DEVELOPMENT ASSESSMENT REPORT				
<b>Application No.</b>	DA/2022/0886			
<b>Address</b>	126 Wells Street NEWTOWN			
<b>Proposal</b>	Subdivision of the existing lot into two Torrens Title lots, and construction of a two storey semi-detached dwelling on each lot with associated landscaping			
<b>Date of Lodgement</b>	19 October 2022			
<b>Applicant</b>	The Trustee for BLU PRINT FAMILY TRUST			
<b>Owner</b>	Ly Projects Pty Ltd			
<b>Number of Submissions</b>	Initial: 7 After Renotification: 5 (unique)			
<b>Value of works</b>	\$999,020.00			
<b>Reason for determination at Planning Panel</b>	Number of submissions			
<b>Main Issues</b>	<ul style="list-style-type: none"> <li>• Submissions</li> <li>• Streetscape impacts</li> <li>• Visual Privacy</li> <li>• Overshadowing</li> <li>• Visual Bulk</li> </ul>			
<b>Recommendation</b>	Approved with Conditions			
<b>Attachment A</b>	Recommended conditions of consent

This report is an assessment of the application submitted to Council for subdivision of the existing lot into two Torrens Title lots, and construction of a two storey semi-detached dwelling on each lot with associated landscaping at 126 Wells Street Newtown. The application was notif

Shadow Diagram - June 21st - 12:00

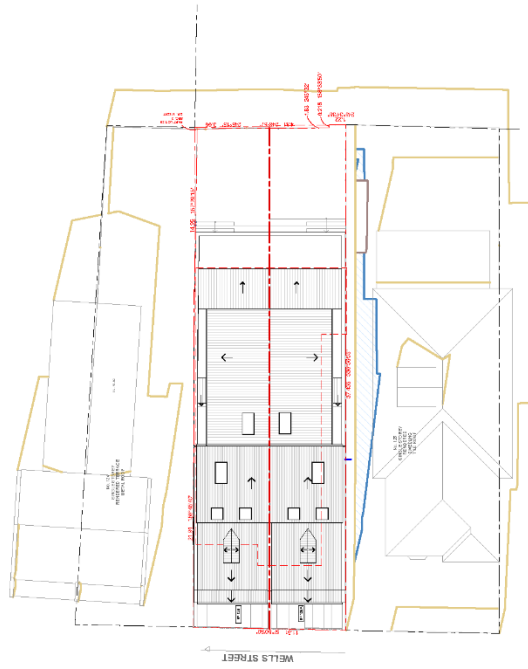
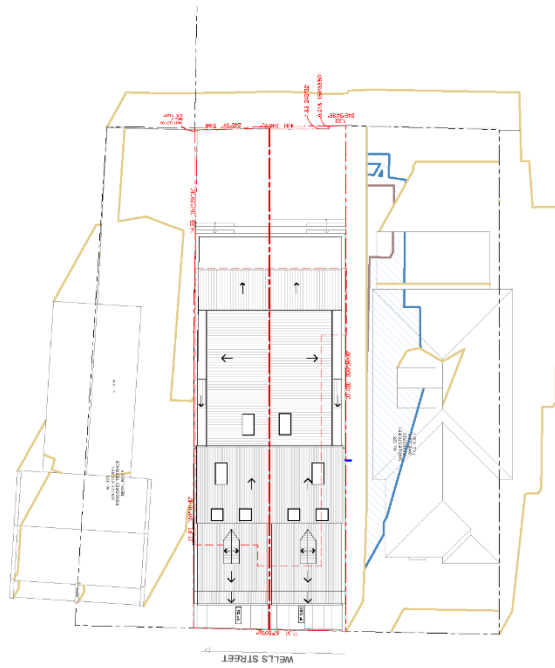
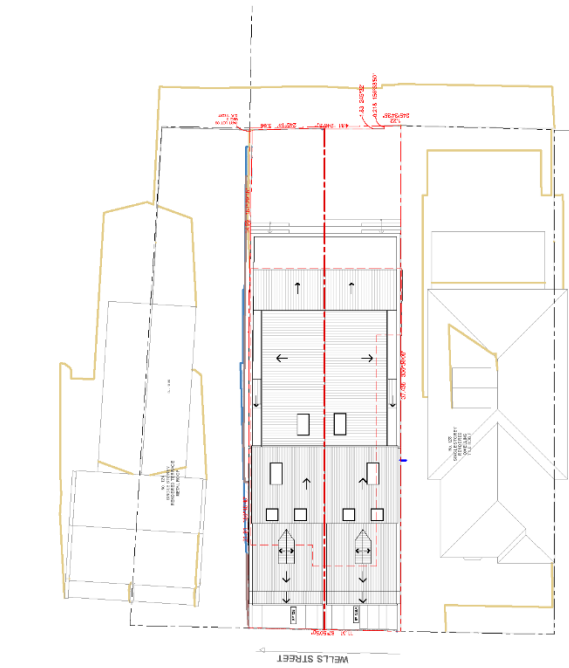
As depicted on the submitted shadow diagrams, the proposal results in additional overshadowing of private open space and windows along the eastern elevation at No. 128 Wells Street (the two rearmost windows, and door, serve living areas (Figure 3)). While the windows are depicted on the submitted survey, they are not shown on the shadow diagrams, and shadow diagrams in elevation for the proposal have not been submitted.

In considering the factors contained in control C2(ii), and relevant considerations of the Planning Principle regarding sunlight, established in *The Benevolent Society v Waverley Council* [2010] NSWLEC 1082, the additional overshadowing of the windows is considered acceptable for the following reasons:

- The proposal complies with the FSR and height of buildings development standards.
- The windows/doors are side-facing and, given the north-south orientation of the lots, it is difficult to protect solar access to these windows.
- The height of the proposed development, as outlined in detail further below, is considered reasonable and consistent with other development in the streetscape. The proposal has been designed to present as a single storey development at the front and the first floor setbacks are consistent with other first floors in the streetscape and in a location where expected/prescribed under the MDCP 2011.
- While solar access to the windows will also be lost in March/September at 11am, it is retained at 12 noon.
